**Planning & Zoning Commission
Tuesday, July 5, 2022, 6:00 PM
Public Meeting Room / Eagle Town Hall
200 Broadway, Eagle, CO 81631**

1. Project: 435 Eby Creek Apartments Major Development Permit
File #: DR22-03
Applicant: Jeffrey P Manley AIA, Martin Manley Architects
Location: 435 Eby Creek Road
Staff Contact: Peyton Heitzman, Planner II
Request: Seeking approval for a Major Development Permit to construct a 30-dwelling unit apartment building on 2.804 acres.

435 EBY CREEK ROAD
Subdivision: PERRY SUBDIVISION Lot: 3, PHASE II
UPDATED DEVELOPMENT PERMIT SET

Date:	6-22-22
Project number:	2175
SITE PLAN	
A1.1

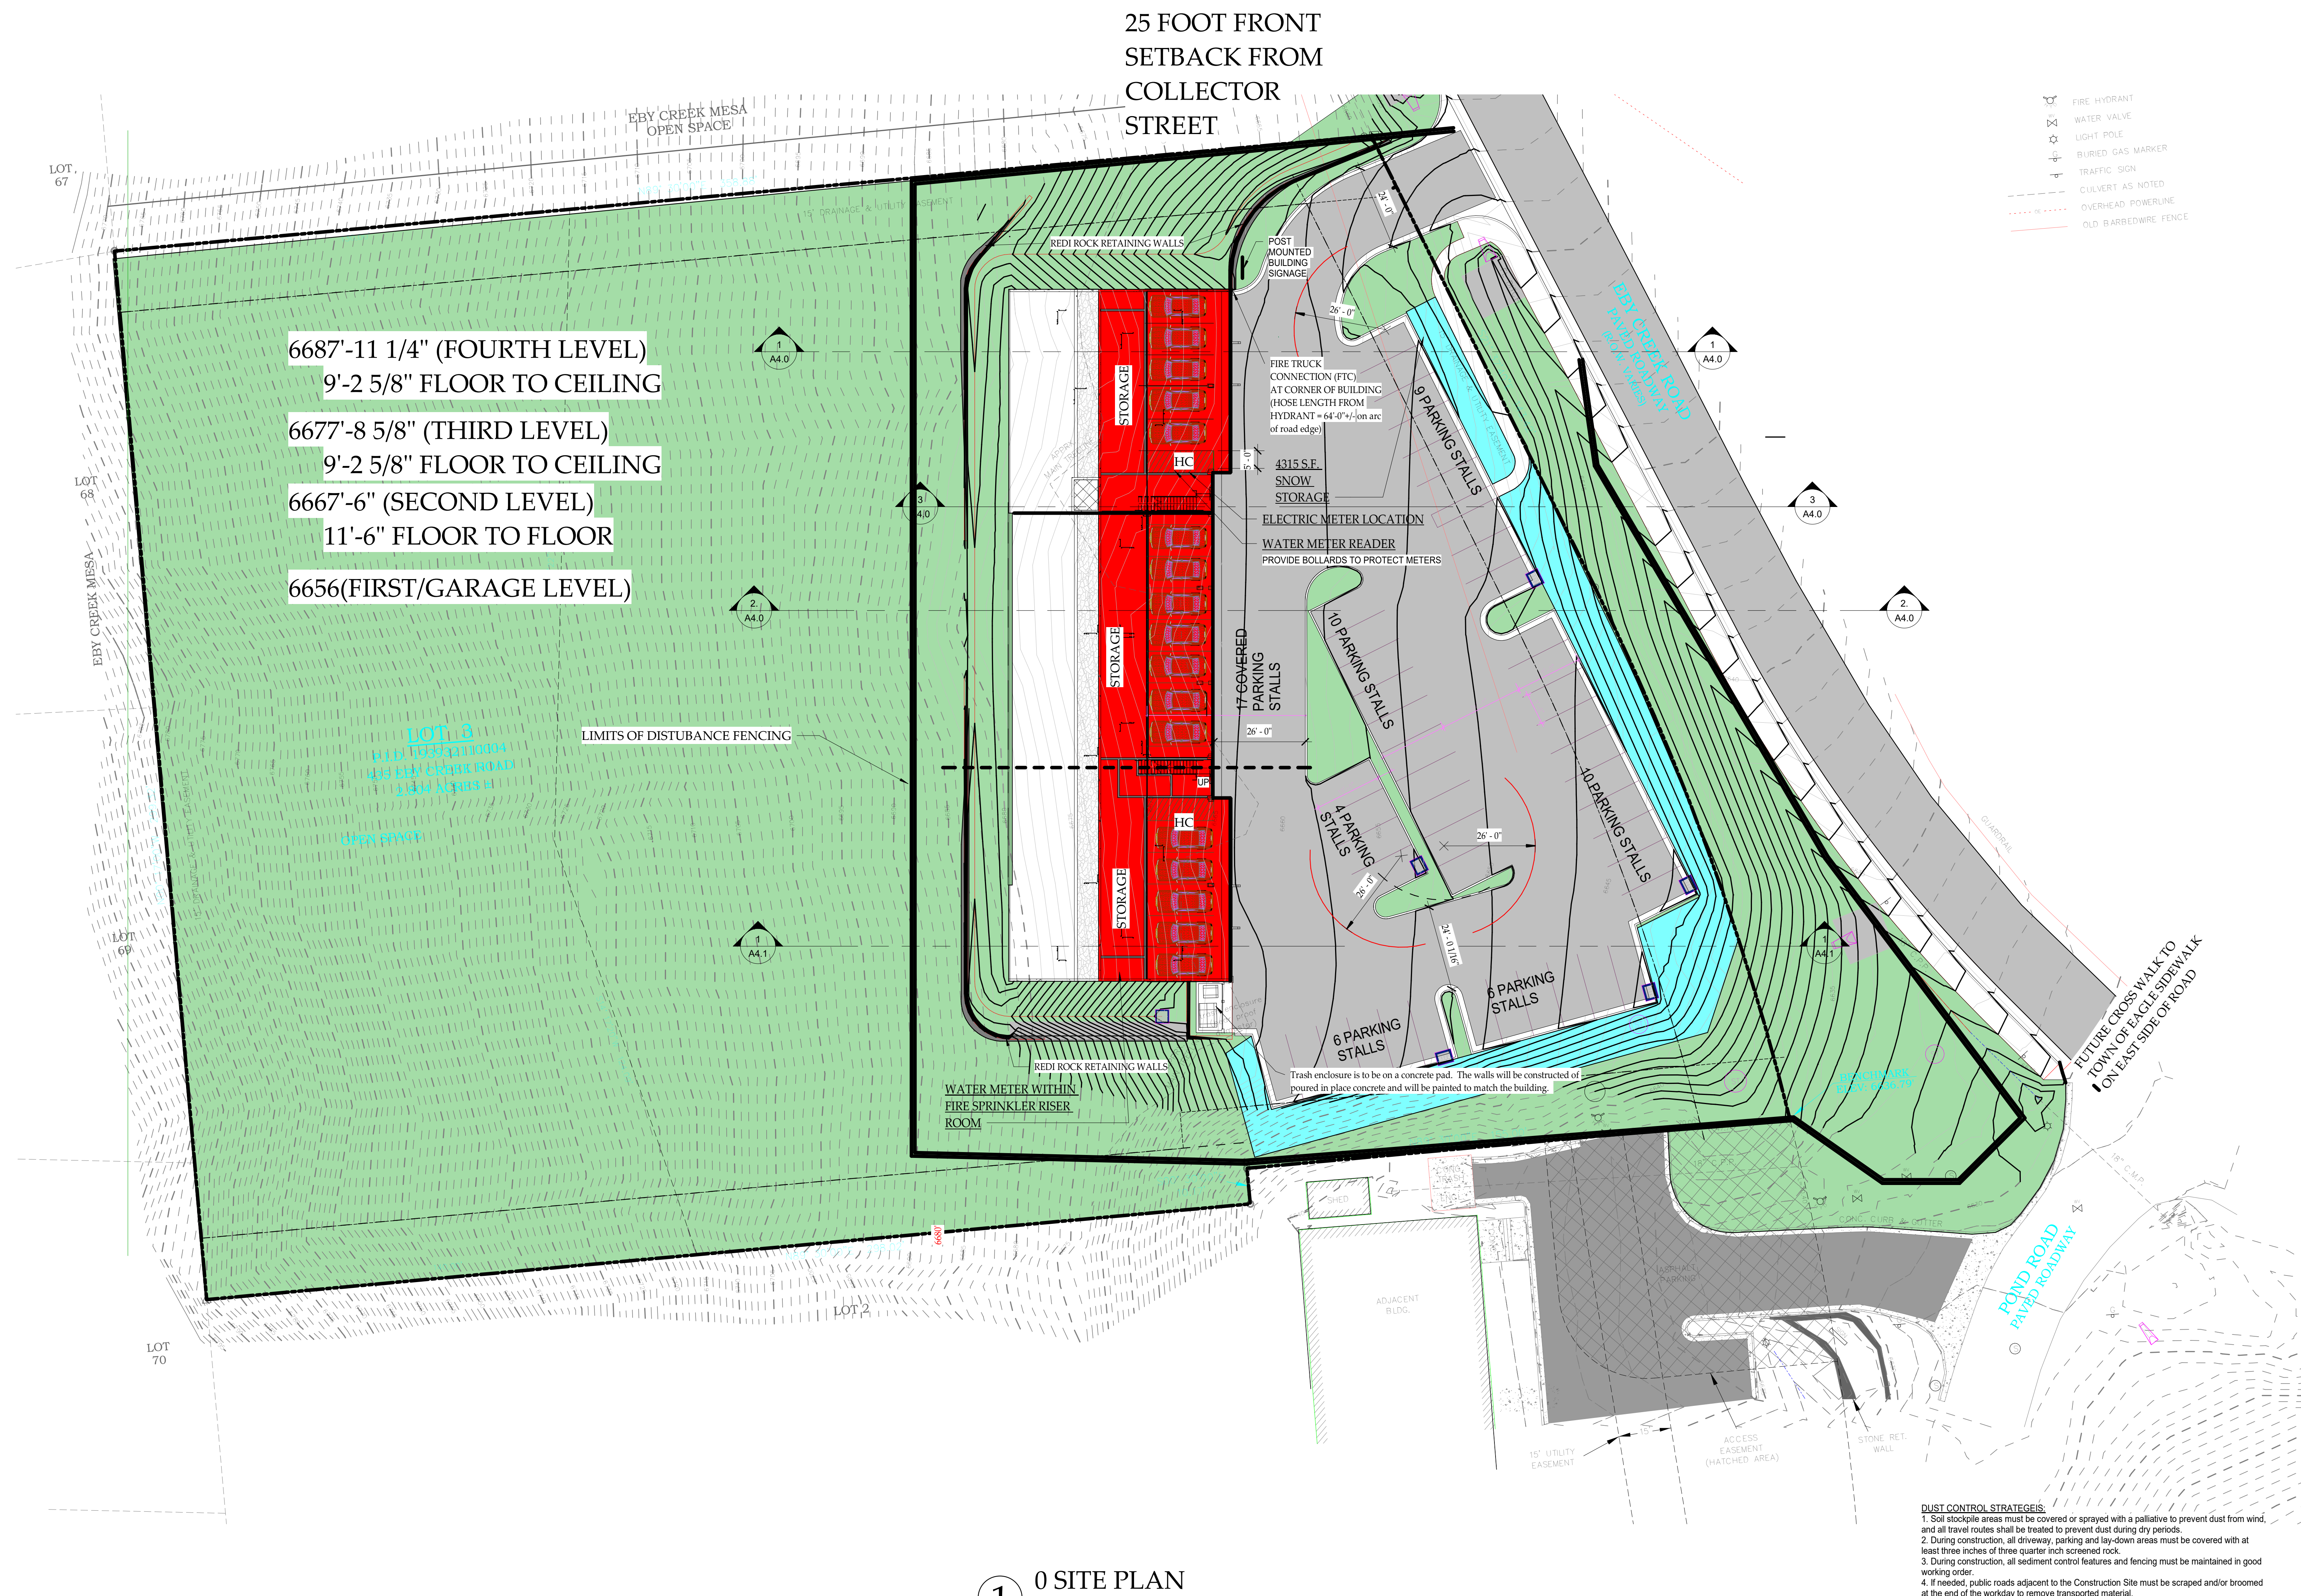
Staff Comment: The trash receptacles will be enclosed and screened from public view. The plans show easy ingress and egress for trash hauling vehicles. Sheet A1.1 shows that the dumpster will be placed on concrete pads.

Staff Comment: The development design meets the minimum parking space requirement. Of the parking provided, 17 spaces are located under the structure and 45 spaces are located in the unenclosed parking lot. The size of the parking stalls throughout the development are 9' X 19' (Sheet C3) and comply with size requirements in Section 4.07.140.D. Asphalt is proposed for the parking surface area, a permitted material under Section 4.07.140.K.a.b.

Staff Comment: All of the proposed parking stalls are designed to a 90-degree angle and subject to the layout requirements in the table above. The site plan on Sheet A1.1 provides the minimum stall width and length. The aisle width is 24' through the majority of the drive. In front of the building the aisle will be increased to 26' to accommodate a fire truck. There is a 62' aisle with for the parking area with a double row.

Staff Comment: Sheet A1.1 provides a location for a monument sign on the northeast end of the building. Since the details of the sign are limited, staff has included a condition of approval requiring the monument sign be approved through the Town sign permit process, subject to the standards in Chapter 4.08.

Date:	6-22-22
Project number:	2175
EXTERIOR ELEVATIONS	
A3.1

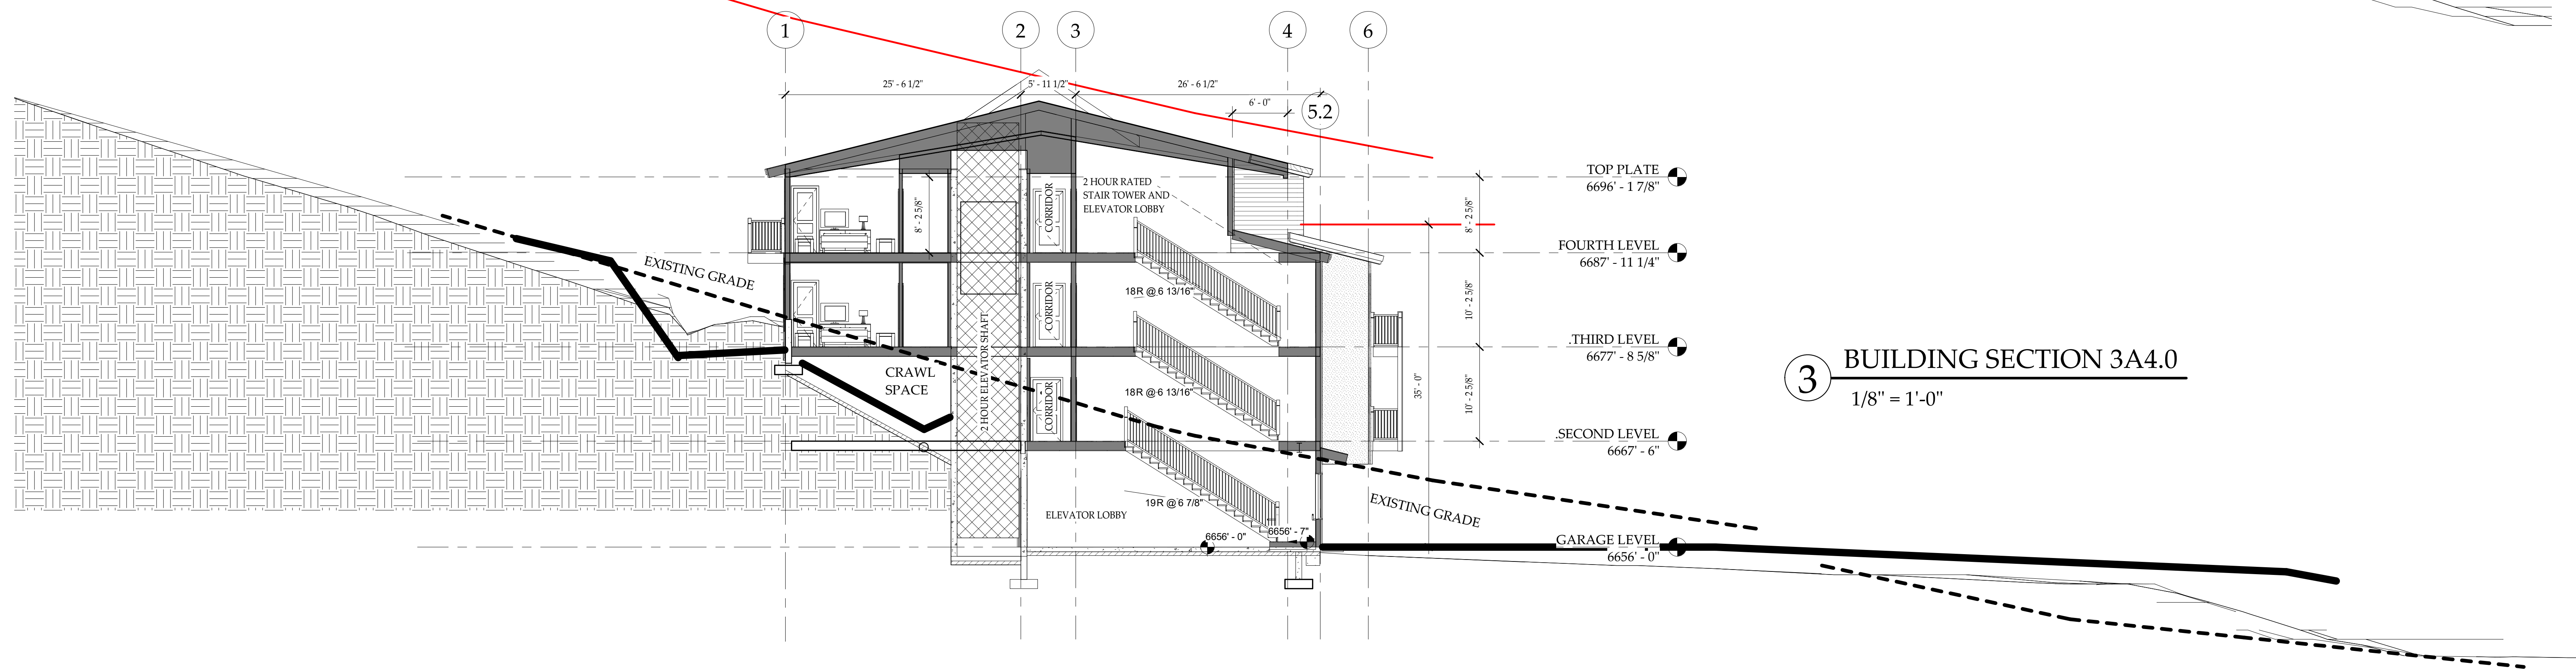
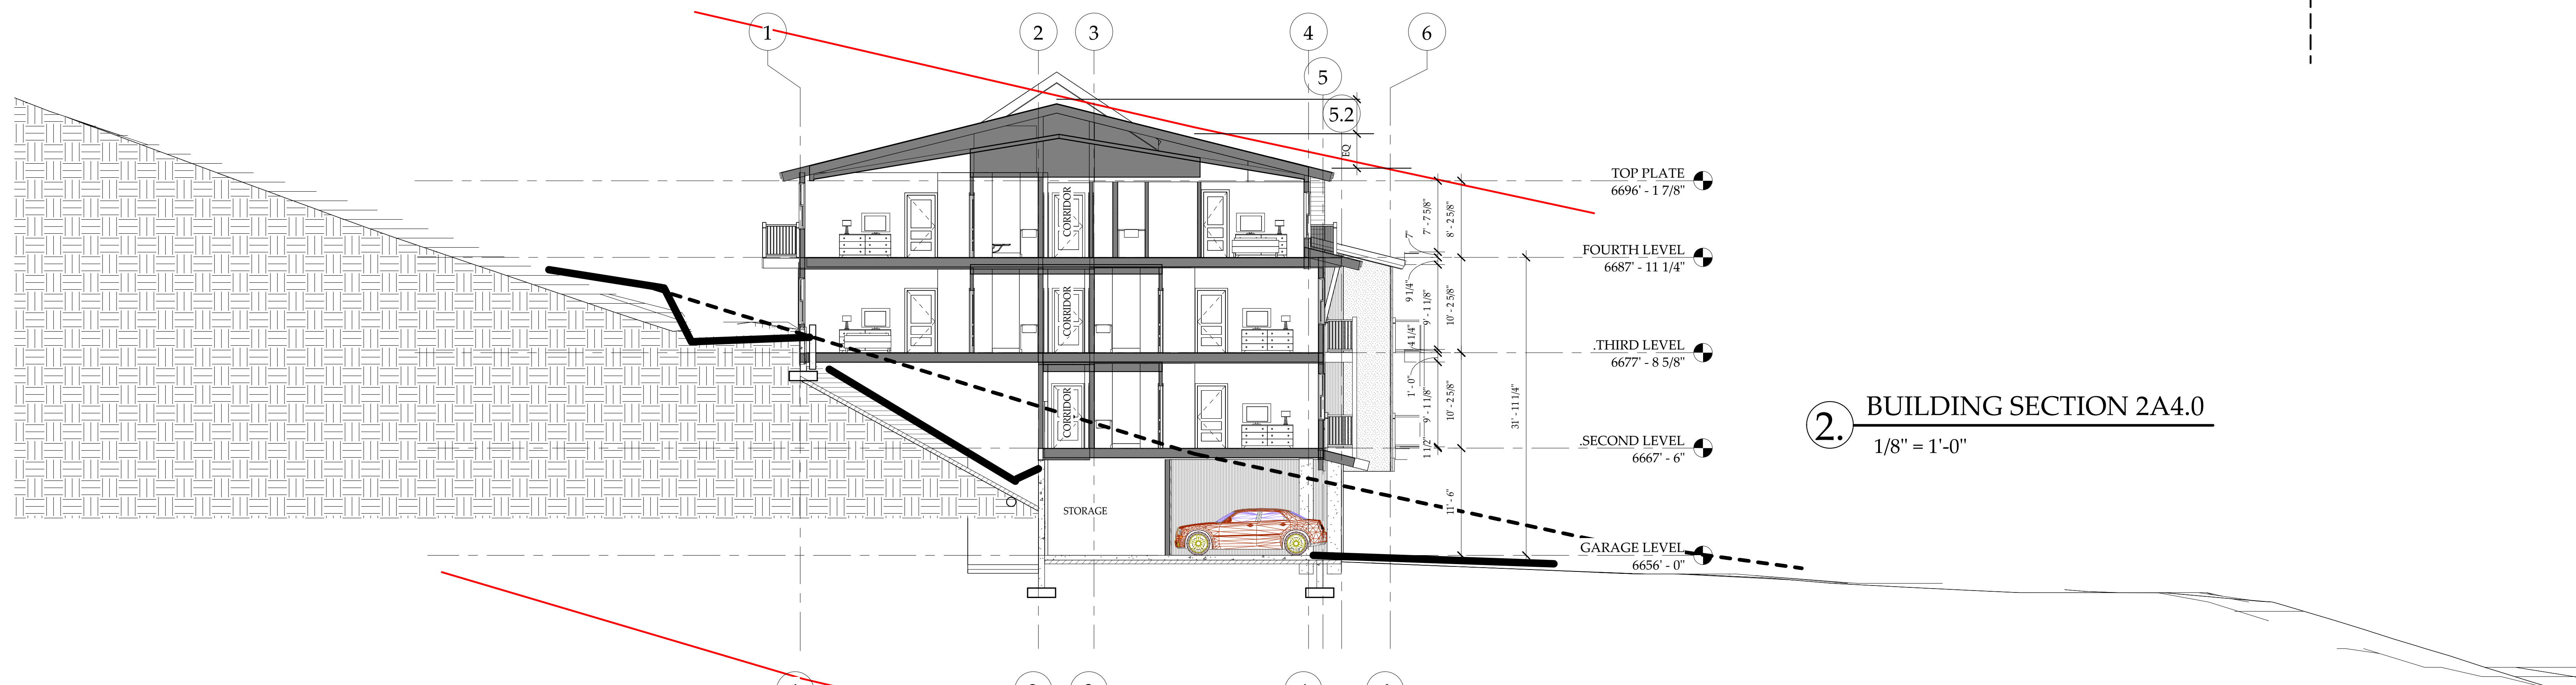
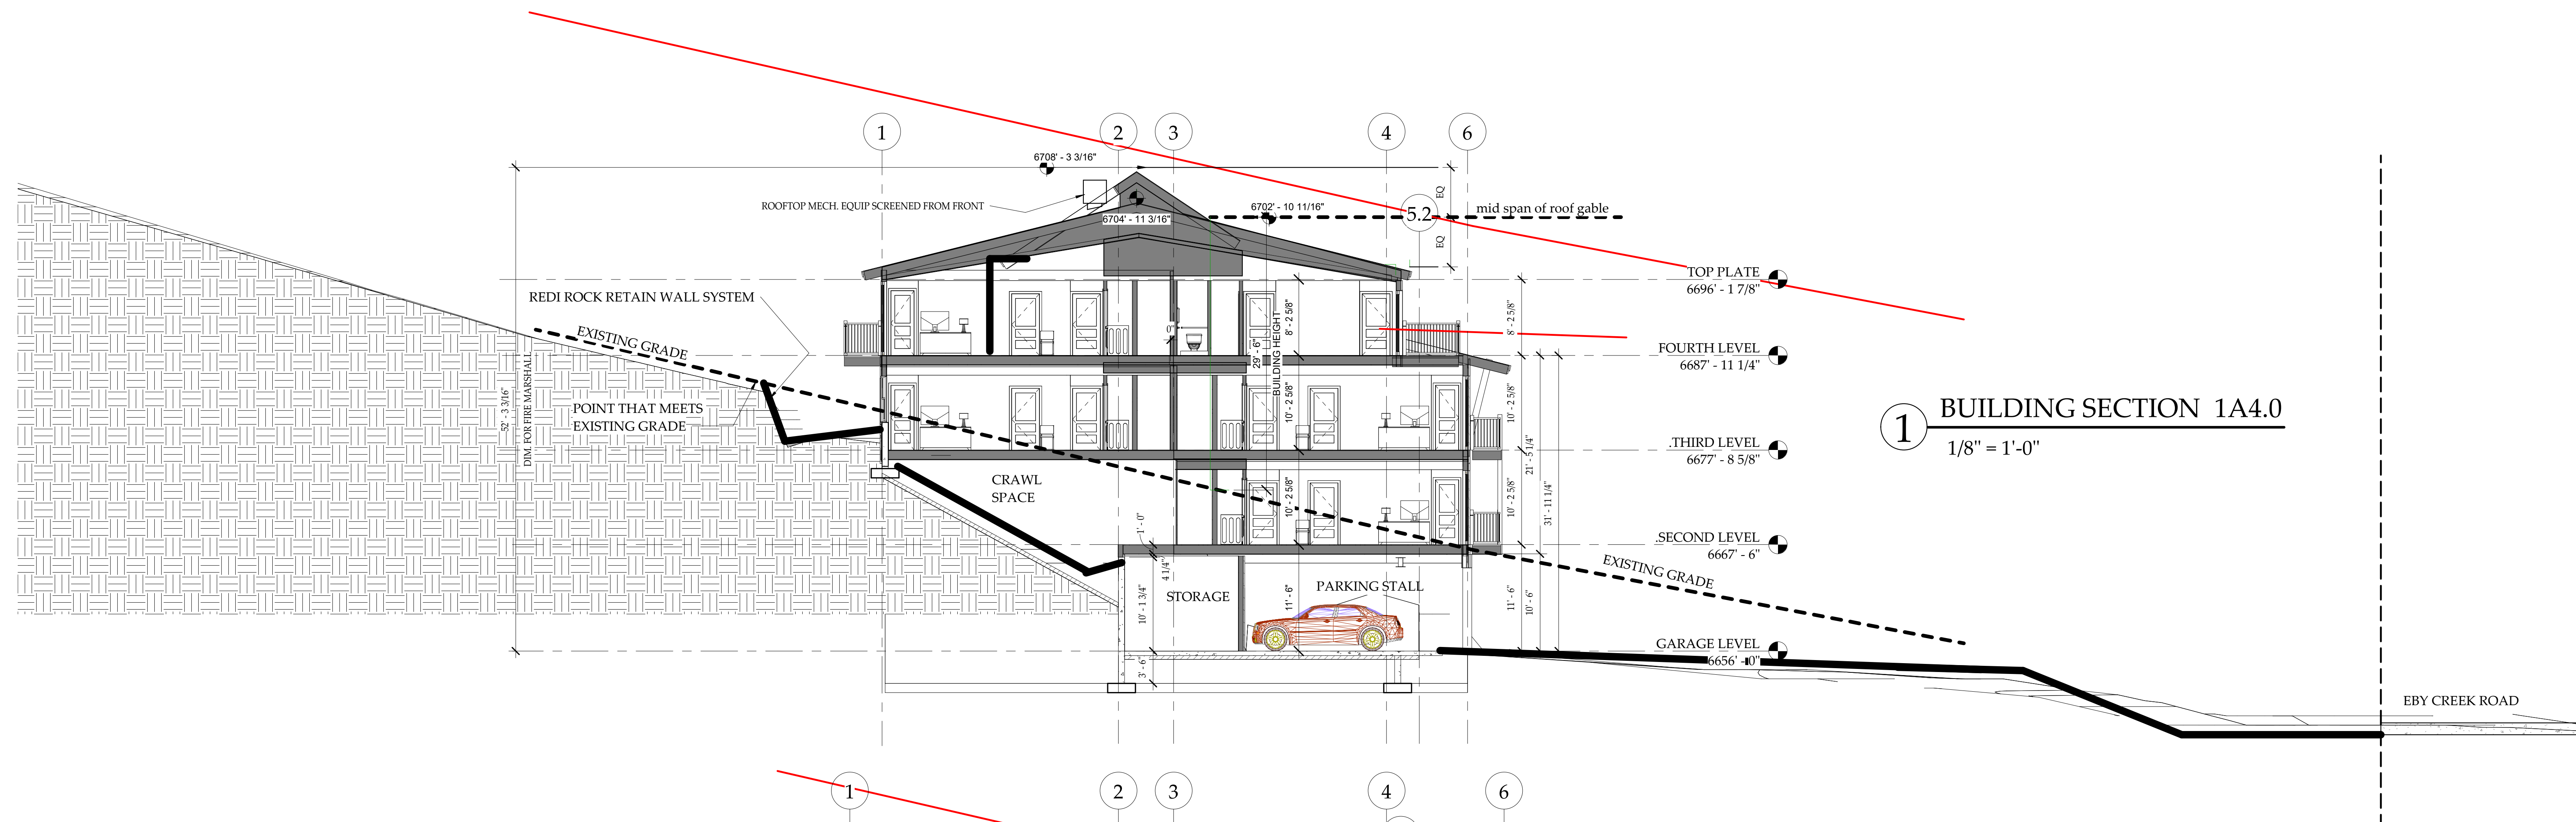
Staff Comment: The colors for each individual material can be found on Sheets A.0 and A3.1. Staff believes the proposed colors are subtle and earth toned.

Staff Comment: The Applicant is proposing dark bronze window trim and graphite timbers, trim and fascia (Sheets A.0 and A3.1). Staff believes the proposed trim and accent areas are complementary colors and comply with this standard.
